Proposed magnet alignment changes for AP-1

February 2, 2001

James Morgan

PBR1 Realignment

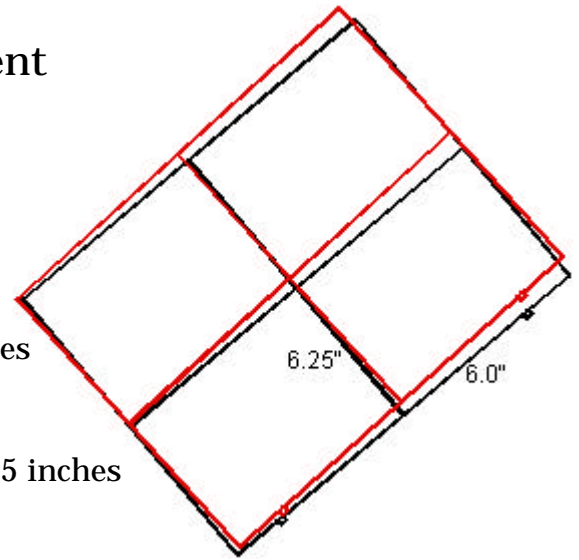
Move towards wall (left in proton direction)

Upstream +0.240 inches, Downstream +0.160 inches

Vertical

Raise Upstream +0.170 inches, Downstream +0.175 inches

Make roll angle 41.0°

New Desired centroid

Horizontal (from Murphy line)

Upstream 27.481 inches, Downstream 29.988 inches

Vertical (inches above 720 foot elevation)

Upstream 89.626 inches, Downstream 93.127 inches

PBR2 Realignment

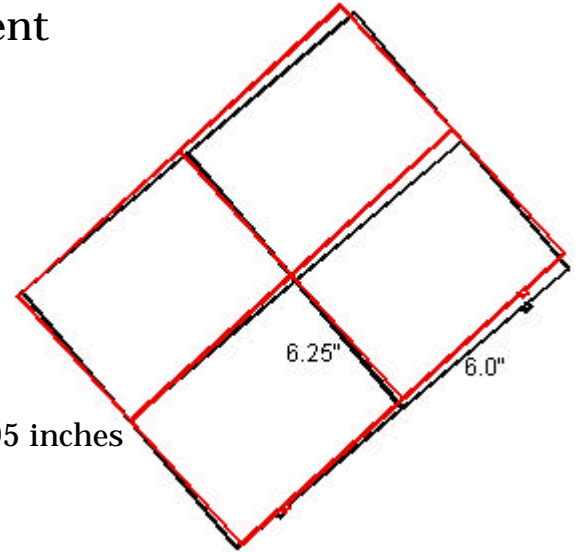
Move towards wall (left in proton direction)

Upstream +0.330 inches, Downstream no move

Vertical

Raise Upstream +0.140 inches, Downstream +0.095 inches

Make roll angle 41.0°

New Desired centroid

Horizontal (from Murphy line)

Upstream 30.492 inches, Downstream 33.644 inches

Vertical (inches above 720 foot elevation)

Upstream 93.474 inches, Downstream 96.059 inches

AP-1 Horizontal Survey

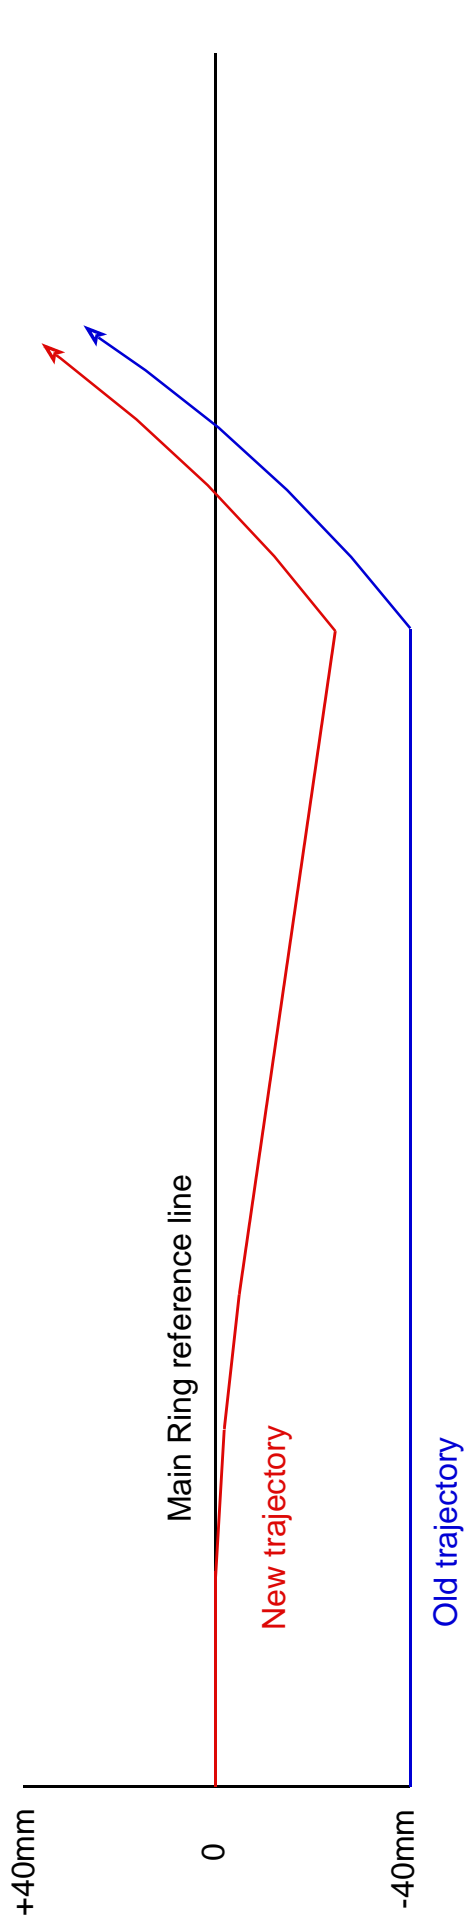
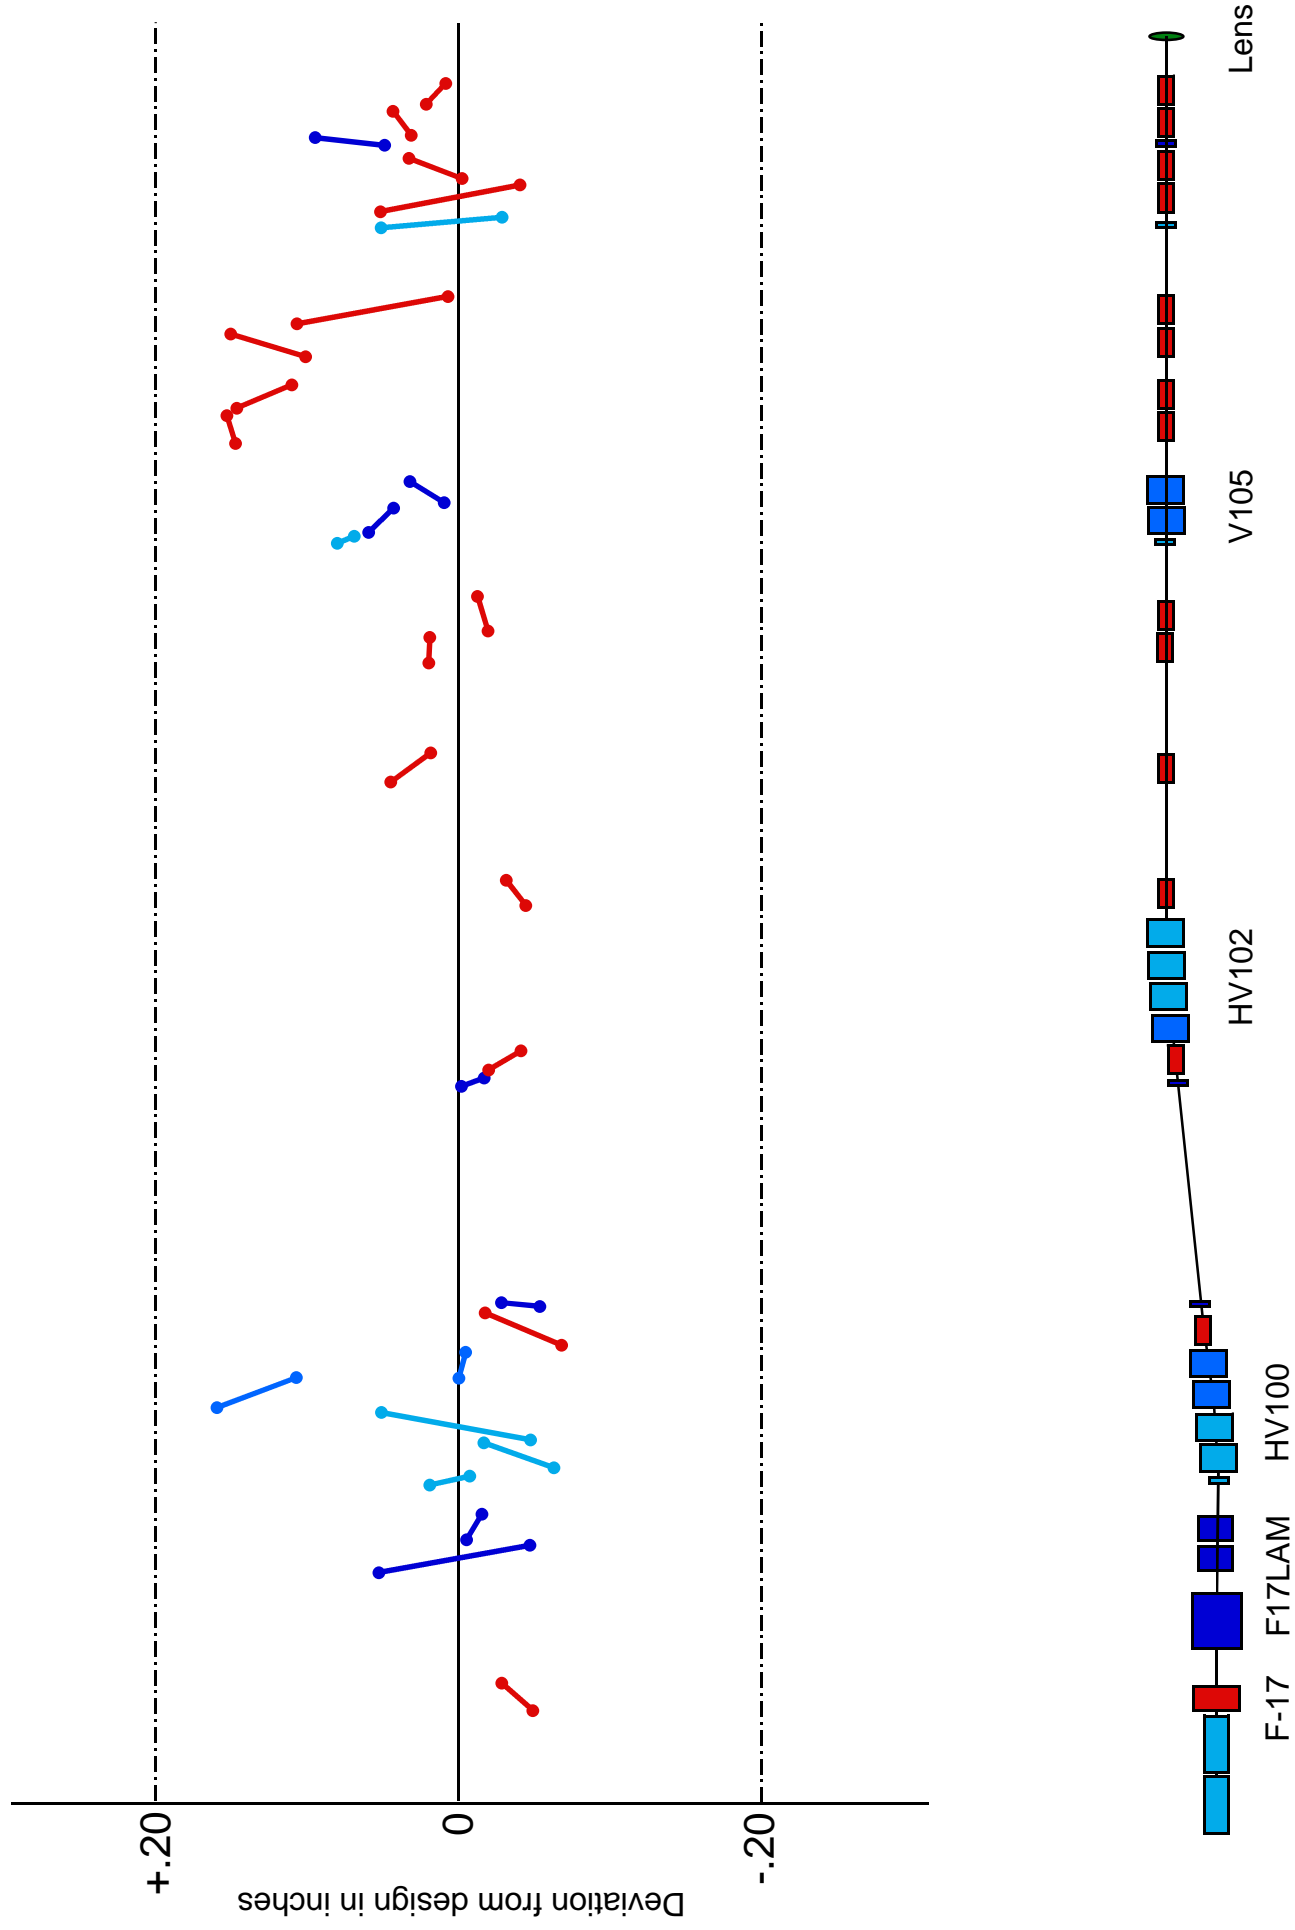
The horizontal survey (figure 2) shows mostly small deviations from design through AP-1. The most significant offsets from desired positions occur in the PQ6A&B and PQ7A&B quadrupoles. Not shown in the figure are survey errors on Beam Position Monitors and SEM grids. There are several devices that deviate .25 inches or more from the desired positions. In comparing the F-17 to PB1 section of AP-1 that has new desired positions, there appears to be an offset to the right (proton direction) in the PB1,2 and PBR1,2 magnets. In figure 4, old and new survey data are compared to what is expected based on magnet transfer function data. Offsets from the present locations in order to follow this new ideal trajectory are shown in figure 5.
